**Dillon's – near the SW corner of NE Tudor Rd. & NE
Douglas St.**

**Rezoning & Preliminary Development Plan
PL2026-035**

Road Improvements

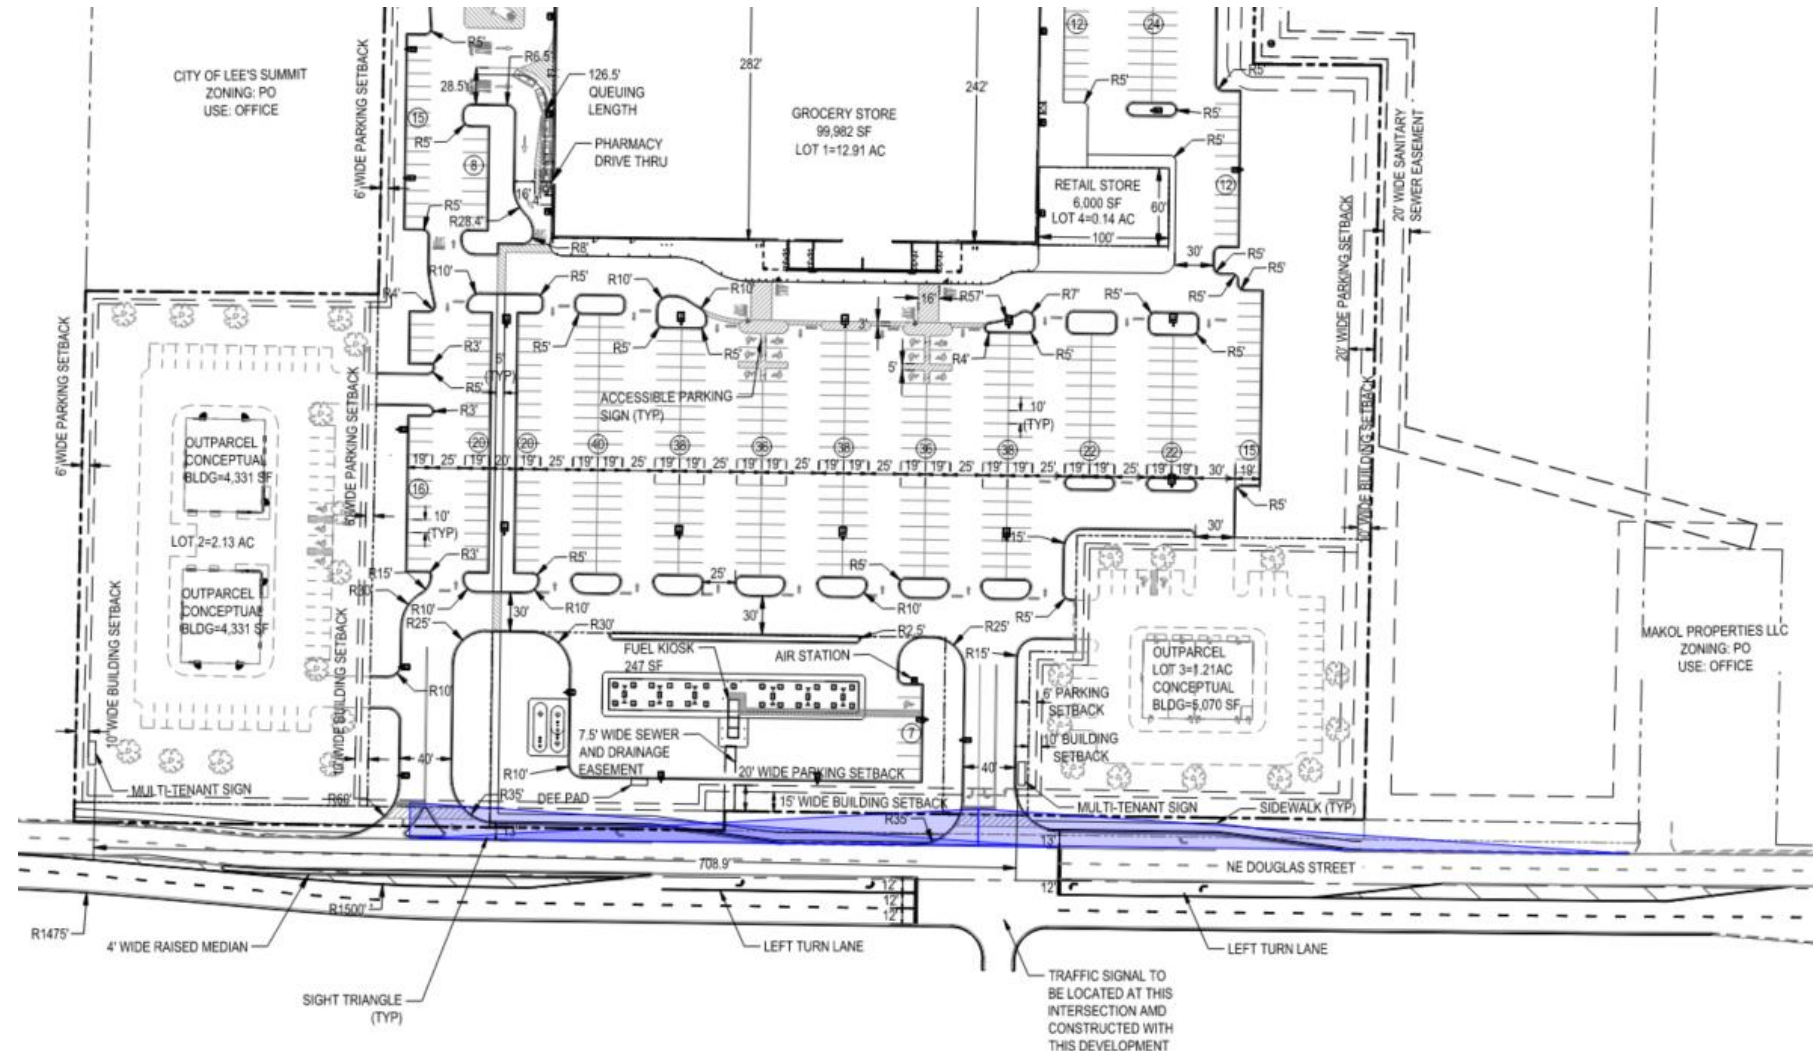
- Signalization of the full access drive at Lee's Summit North Driveway along NE Douglas St.
- Addition of northbound and southbound left turns at the signalized intersection
- Southbound right turn lanes
- Access restrictions for the southern access on NE Douglas St.
- Raised concrete median along NE Douglas St.
- 5-ft. wide sidewalk along NE Douglas St. frontage

7. Road improvements shall be constructed as stated in the Transportation Impact Analysis conducted by staff dated May 26, 2026.
8. The architect and staff will work together to amend the fuel kiosk and associated canopy to achieve a design that is more cohesive with the architecture of the principal building. **(added by Planning Commission)**

Above: Initially proposed fuel kiosk & canopy (east elevation facing NE Douglas St.)

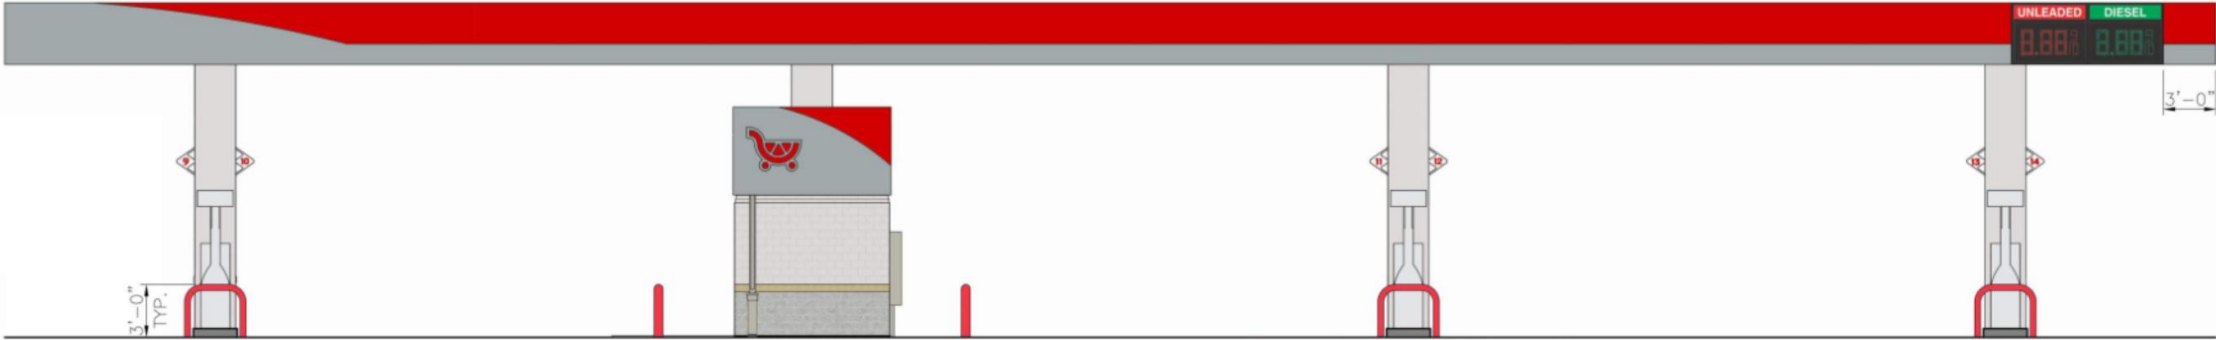
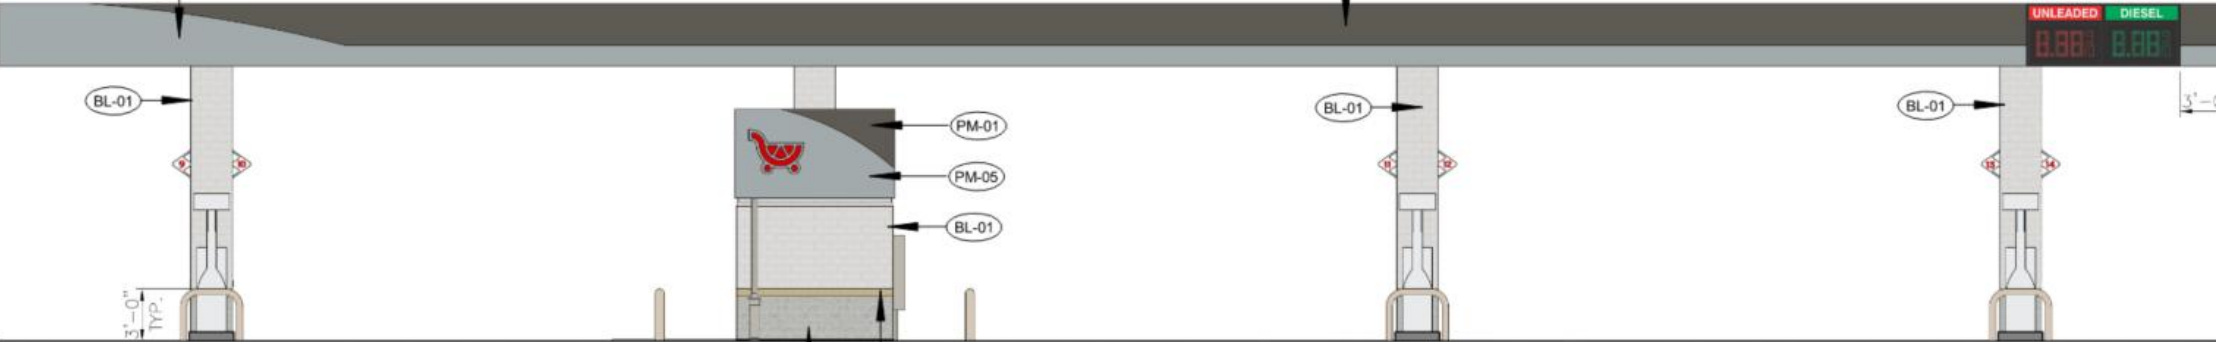
Above: Revised fuel kiosk & canopy (east elevation facing NE Douglas St.)

Major Façade Materials – Modification Request

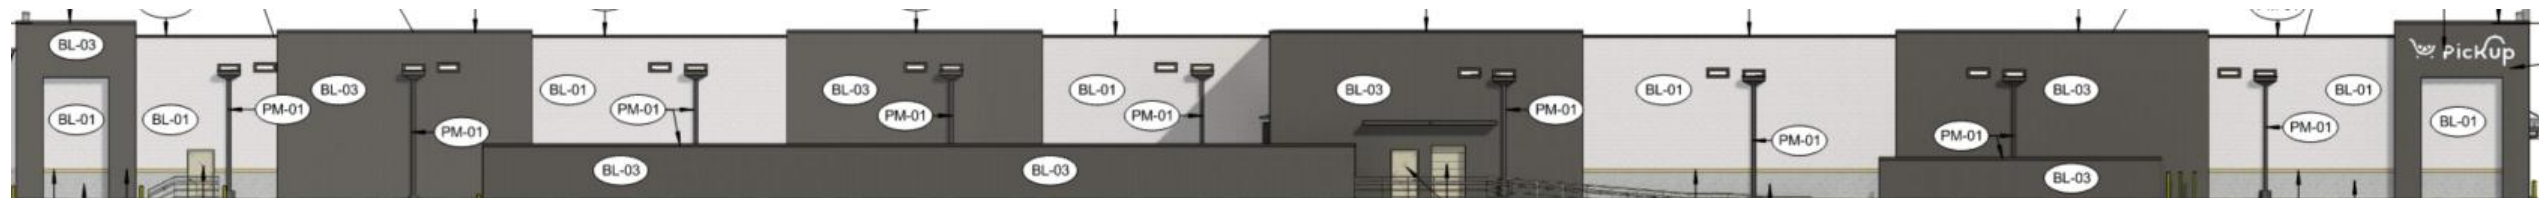
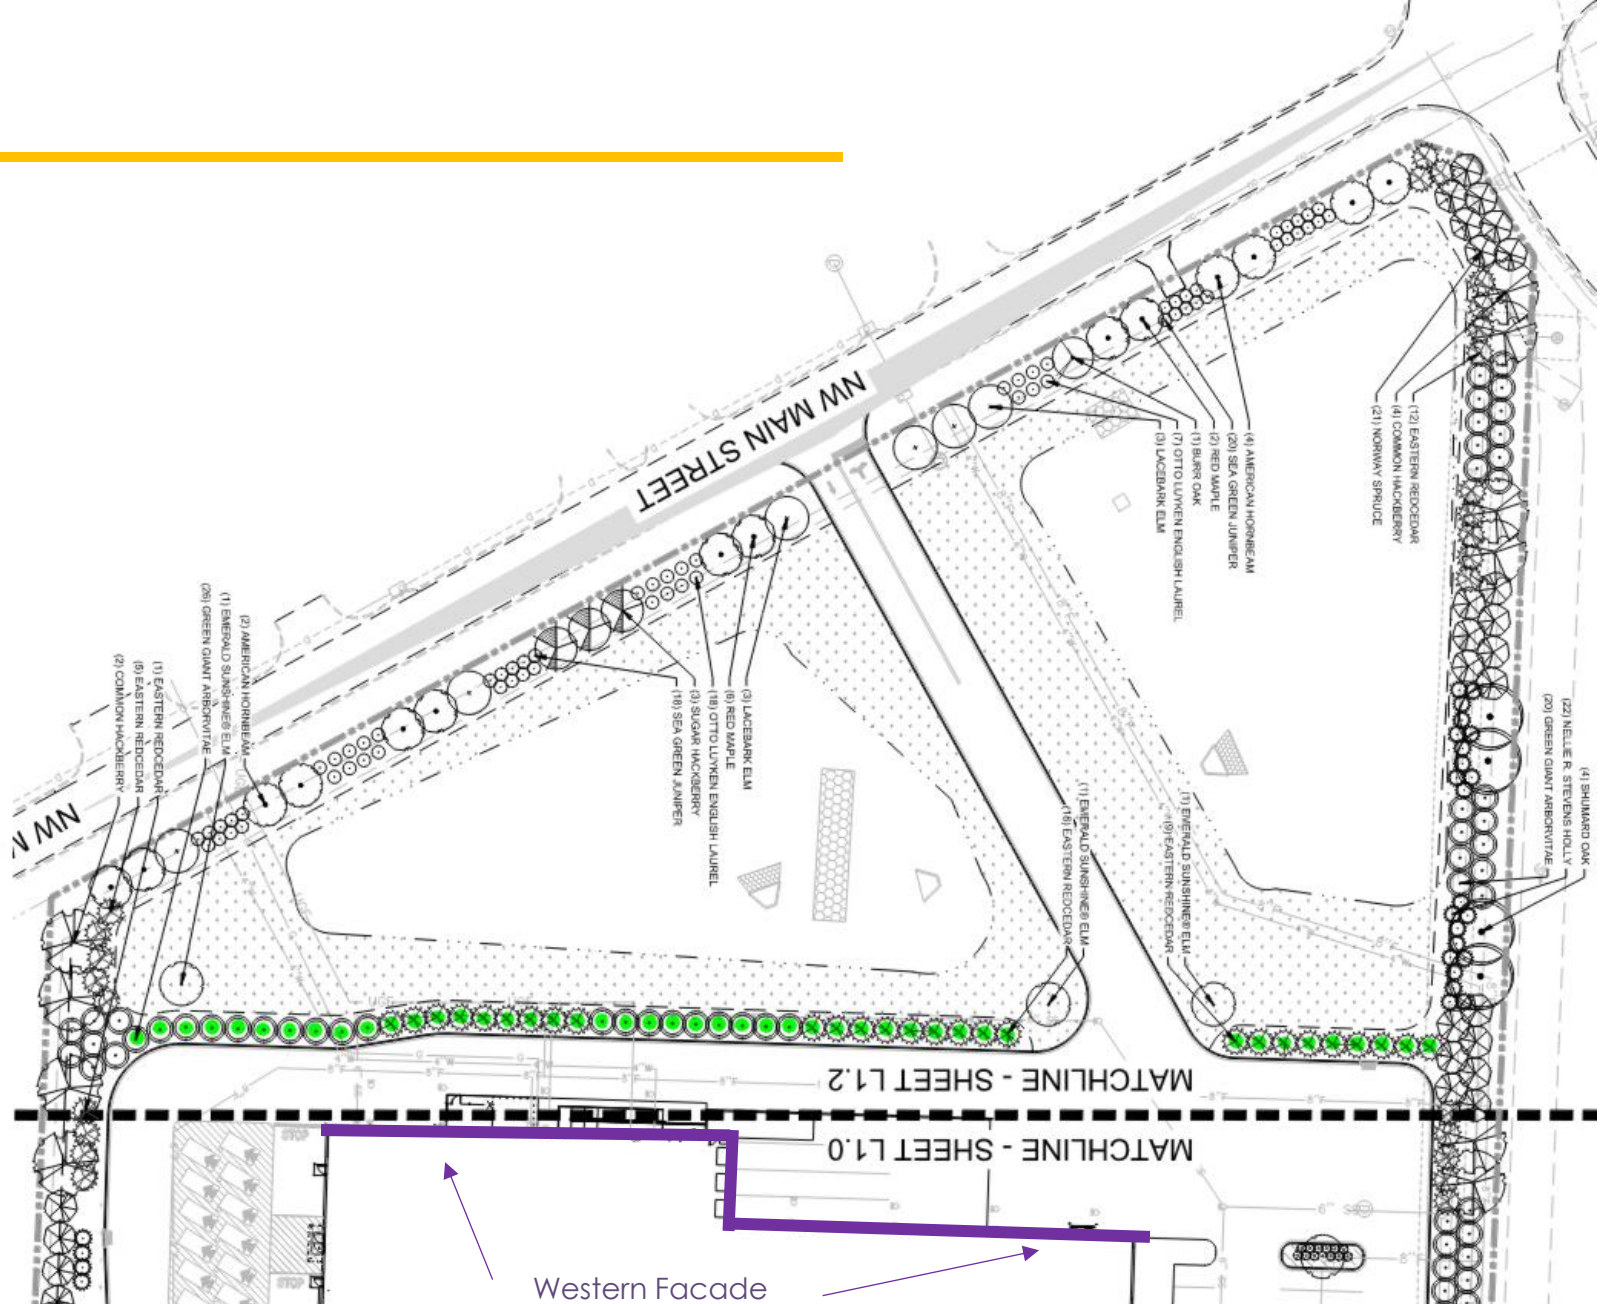
Requirement: Each primary façade shall have no less than 3 different Class 1 or 2 building materials together comprising at least ½ of the façade area.

Proposed: The applicant is proposing 1 Class 2 material in two different colors to comprise 92% of the western façade.

BACK (WEST) ELEVATION AREA = 9,272 SF

• GLAZING	0 SF
• GROUND FACE CMU (BL-01)	3,255 SF
• GROUND FACE CMU (BL-03)	5,296 SF
• GROUND FACE CMU (BL-04)	0 SF
• METAL PANEL (MP-01)	0 SF
• METAL PANEL (MP-02)	0 SF
• METAL PANEL (MP-03)	0 SF

• COMBED FACE CMU (BL-05)	74 SF
• SPLIT FACE CMU (BL-02)	443 SF

6. The western façade shall comply with all applicable requirements of Section 8.080.B. Specifically, the façade shall incorporate no fewer than three (3) different Class 1 or Class 2 building materials, with those materials collectively comprising at least fifty percent (50%) of the primary façade area.

Fenestration – Modification Request

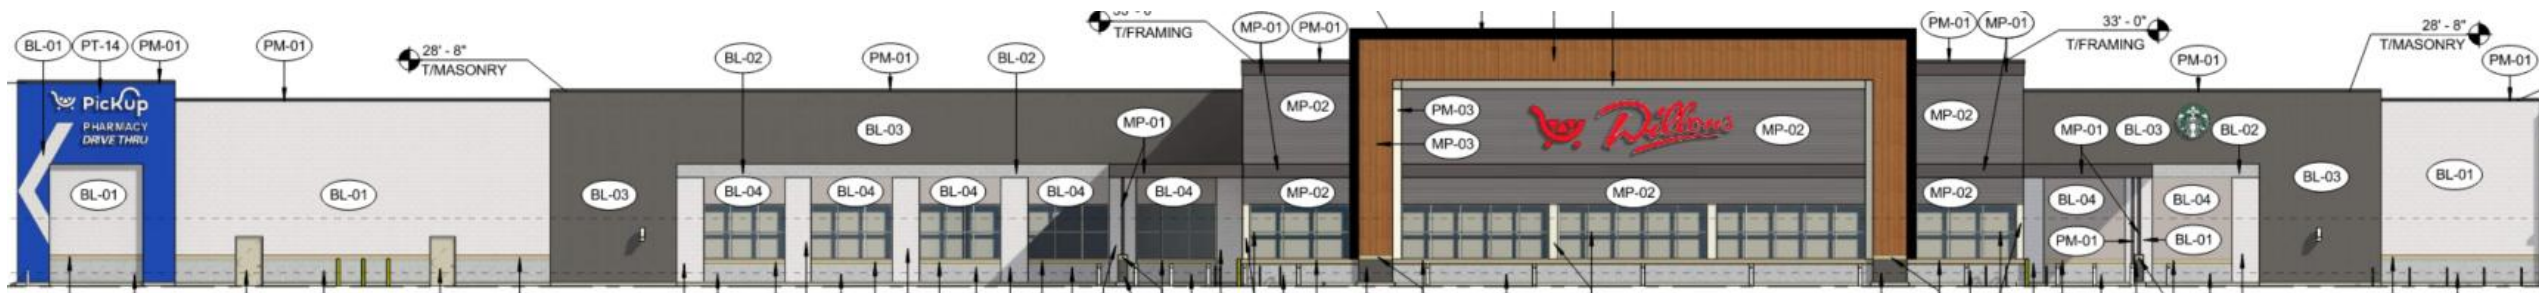
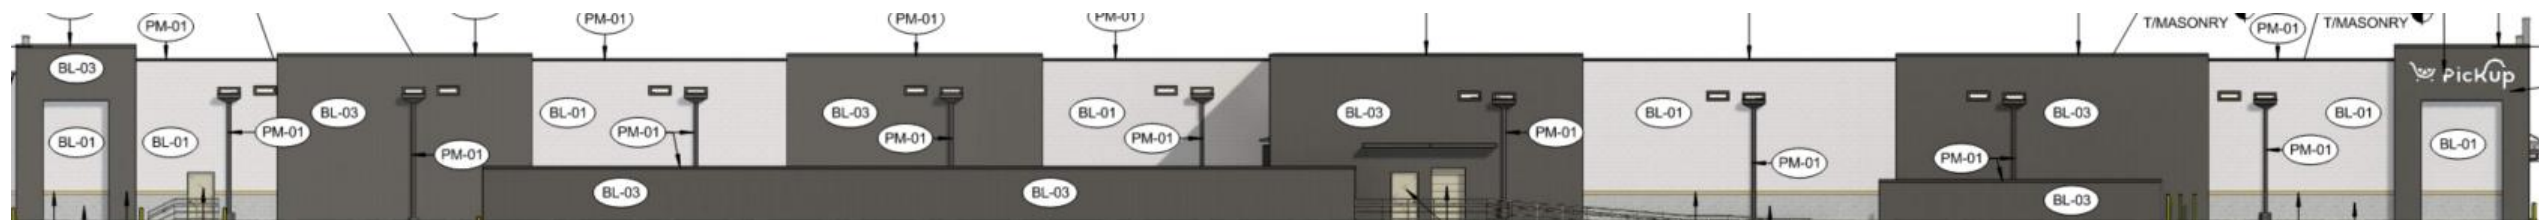
Requirement: Fenestrations with clear glass shall occupy no less than 50% of the pedestrian view zone

The applicant is proposing the eastern façade contain 31% and the western façade contain 0% of clear glass within the pedestrian view zone

- a. The western façade shall be exempt from the requirement.
 - b. The eastern façade shall contain no less than 31% of clear glass within the pedestrian view zone.

Wall Articulations – Modification Request

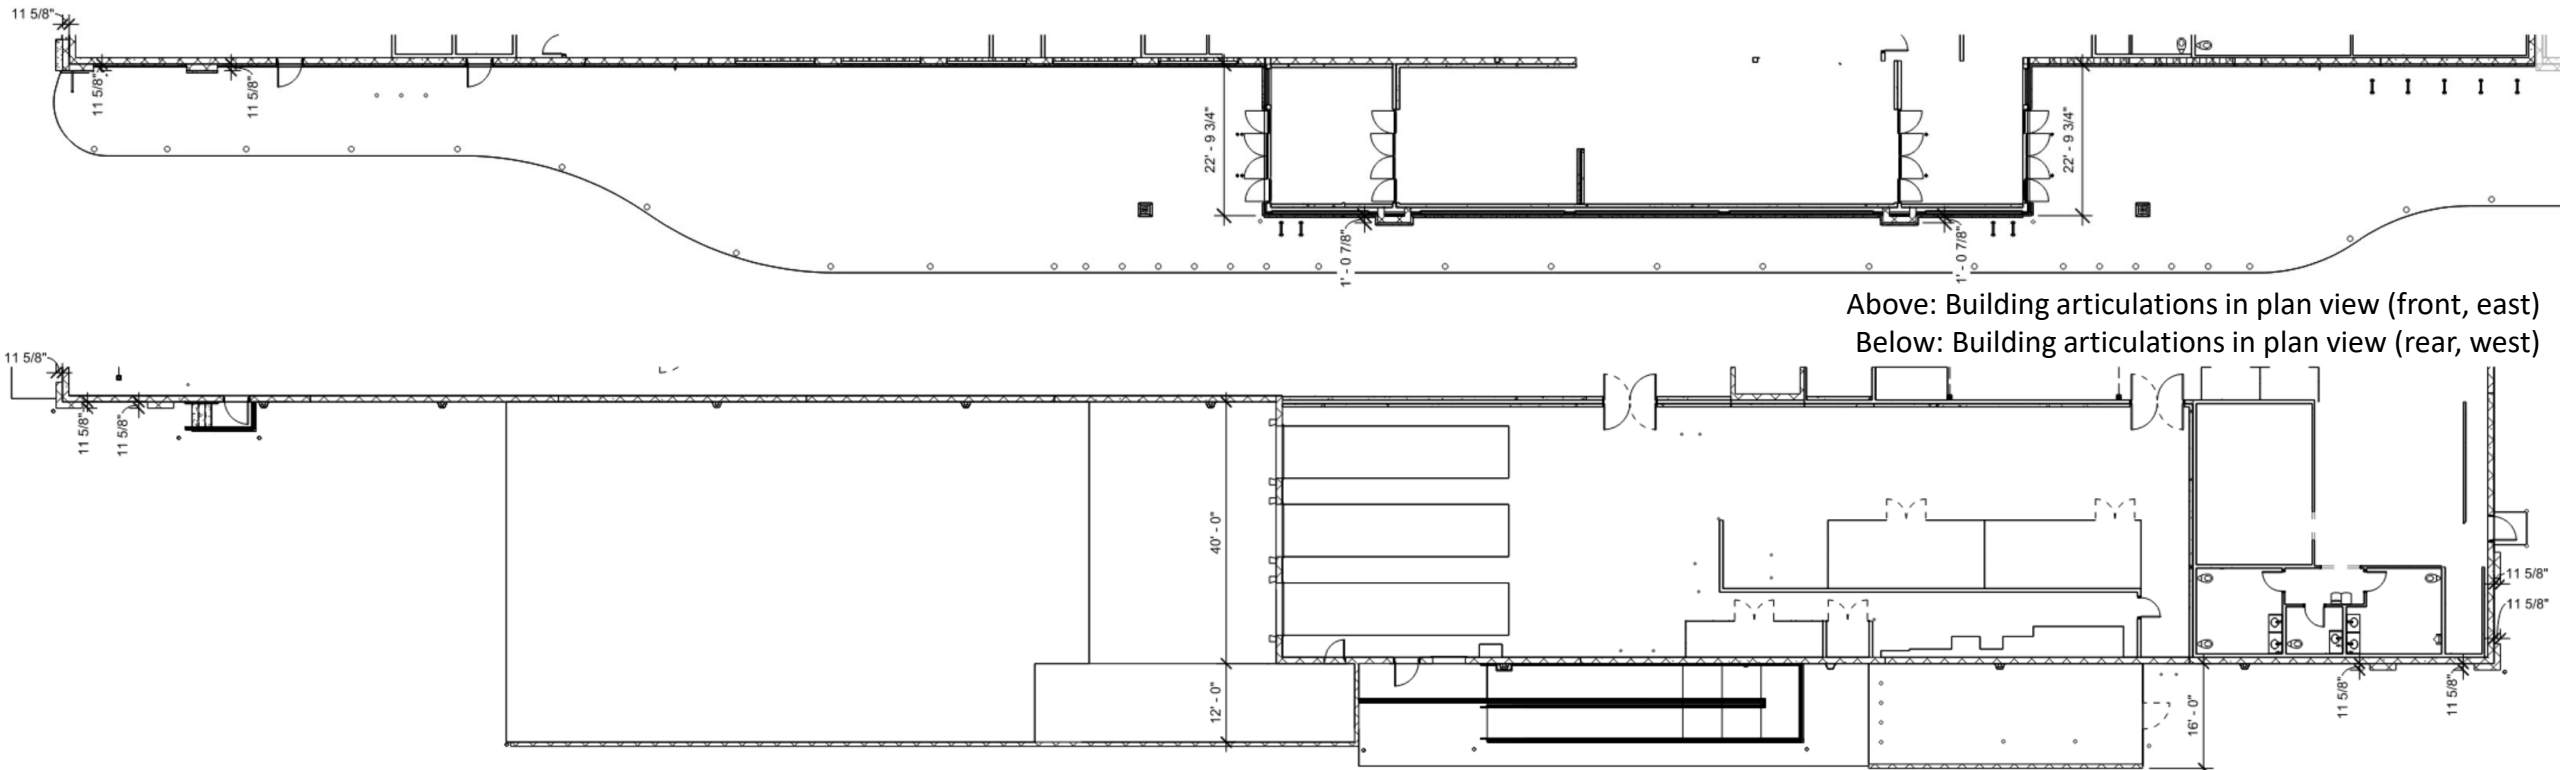
Requirement: The primary façade shall have a wall articulation of at least 2-ft. no less than once every 60 linear feet.

proposing an articulation no less than once every 181 linear feet on the east façade and no less than once every 130 linear feet on the west façade .

3. A modification shall be granted to UDO Sec. 8.080.B to allow for building articulations as submitted in the Preliminary Development Plan with a revision date of May 26, 2026.

Parking Lot Lighting – Modification Request

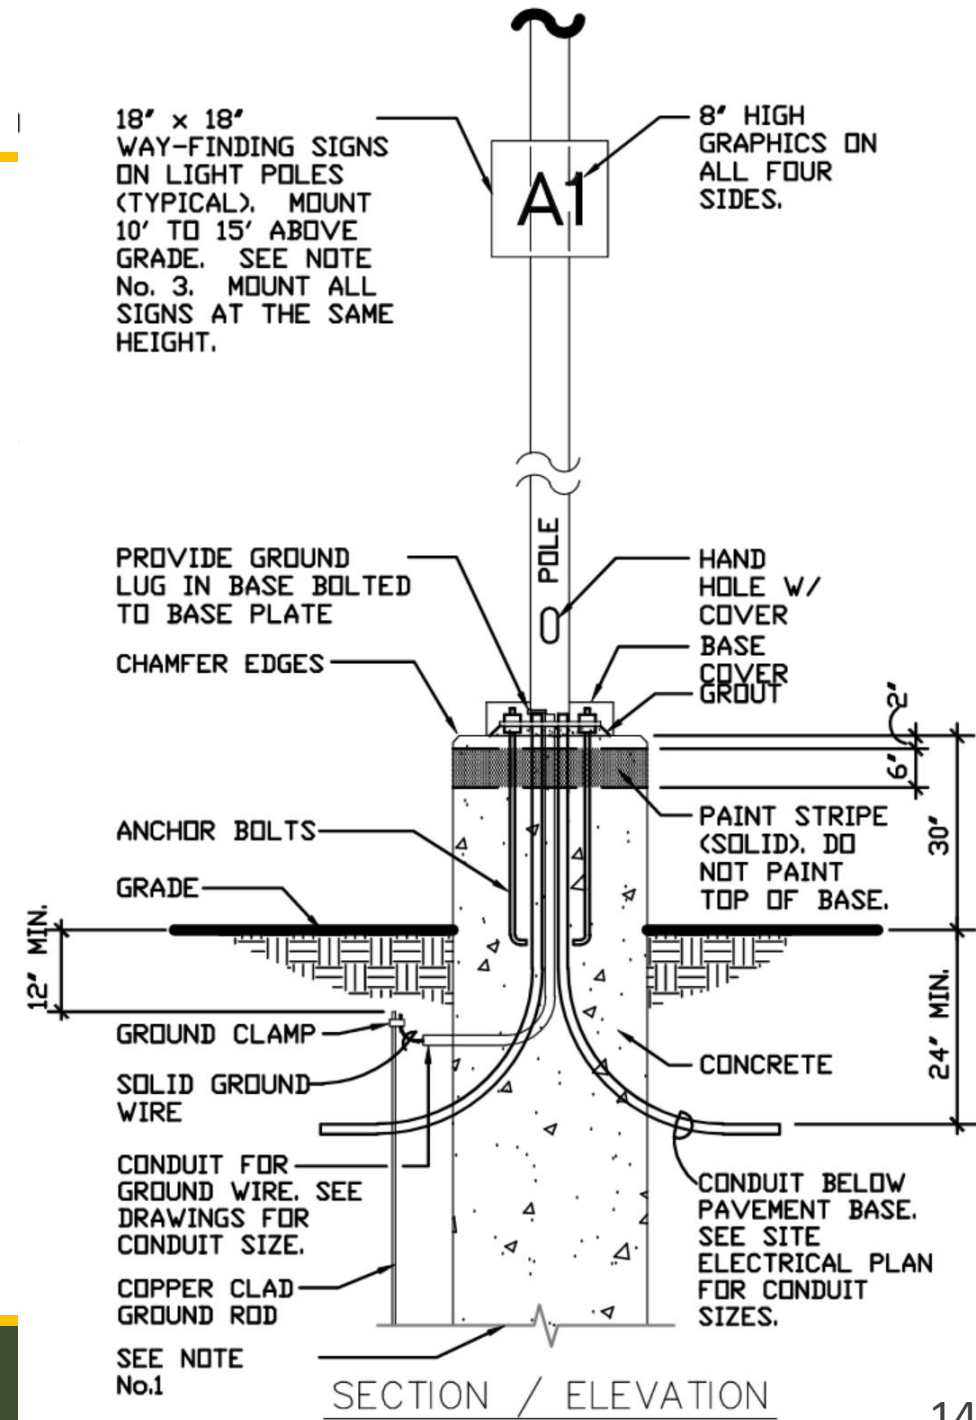
Requirement: All light fixtures on properties within or adjoining residential uses and/or districts shall not exceed 15-ft. in height within 100-ft. of the property line closes to the residential use. Outside the perimeter area, the overall height may be increased to 20-ft.

Proposed: The applicant is proposing the parking lot light poles be 28-ft. in height from grade inclusive of the concrete base.

4. A modification shall be granted to UDO Sec. 8.250.D.1 to allow for the light poles to be 28' tall from grade inclusive of the concrete base.
5. A modification shall be granted to UDO Sec. 8.900.A to allow the proposed grade in lieu of installing a masonry wall, vinyl fence, or berm along the southwestern portion of the property adjacent to the AG zoning along with required landscaping.
